Project	<b>IEEE 802.16 Broadband Wireless Access Working Group</b> < <a href="http://ieee802.org/16">http://ieee802.org/16</a> >
Title	<b>Re-definition of M-ACM-IND Primitive</b>
Date Submitted	<b>2007-02-11</b>
Source(s)	Jaesun Cha and Chulsik Yoon <a href="mailto:jscha@etri.re.kr">jscha@etri.re.kr</a> ETRI 161 Gajeong-dong, Yuseong-gu Daejeon 305-700 Korea
Re:	Contribution on comments to IEEE 802.16g/D7
Abstract	Re-definition of accounting primitives
Purpose	Adoption
Notice	This document has been prepared to assist IEEE 802.16. It is offered as a basis for discussion and is not binding on the contributing individual(s) or organization(s). The material in this document is subject to change in form and content after further study. The contributor(s) reserve(s) the right to add, amend or withdraw material contained herein.
Release	The contributor grants a free, irrevocable license to the IEEE to incorporate text contained in this contribution, and any modifications thereof, in the creation of an IEEE Standards publication; to copyright in the IEEE's name any IEEE Standards publication even though it may include portions of this contribution; and at the IEEE's sole discretion to perm

Figure 471 – Accounting primitive initiated by a BS

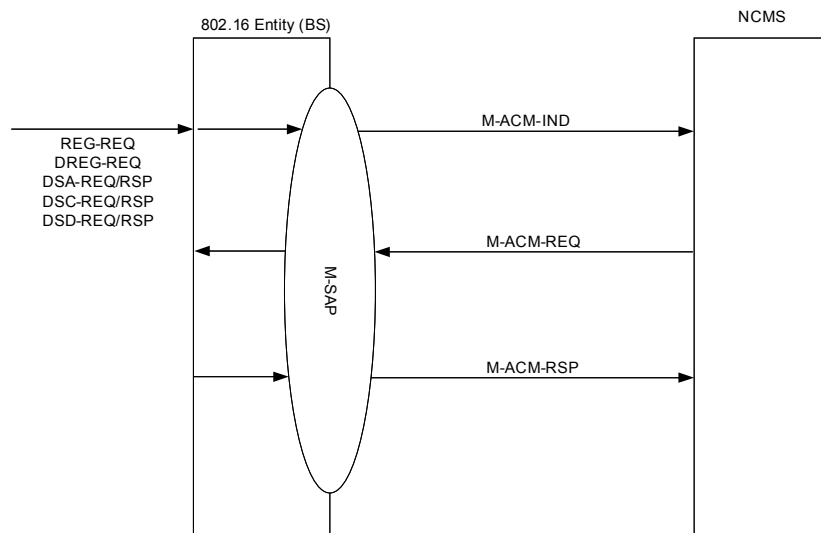
In this contribution, we propose to modify the role of M-ACM-IND primitive. According to the new definition of the M-ACM-IND primitive proposed here, the M-ACM-IND primitive just indicates the NCMS that an event related with accounting has occurred. After the NCMS receives M-ACM-IND primitive, it generates M-ACM-REQ primitive to request the MS to gather accounting information, and the BS responds to it with M-ACM-RSP primitive.

*[Replace Figure 471 with the following figure]*
